DEPARTMENT OF TRANSPORTATION

Federal Aviation Administration

[Docket No. FAA-2009-0323 Directorate Identifier 2009-CE-012-AD; Amendment 39-15937; AD 2009-12-14]

Airworthiness Directives; Aeromot-Industria Mecanico Metalurgica Ltda. Model AMT-200 and AMT-300 Series Gliders

Figure 1 - Correct Installation of Clip for Box Beam

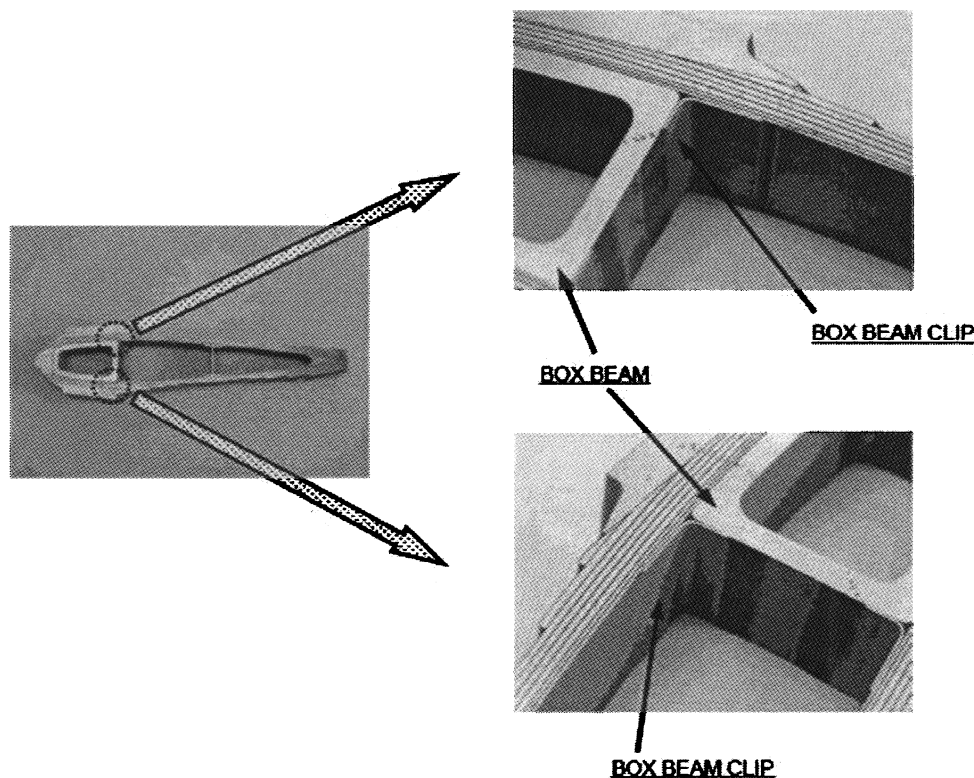
(b) Before further flight, if you find a main rotor blade with an incorrectly installed clip, replace that unairworthy main rotor blade with an airworthy main rotor blade that has a clip that is installed correctly.
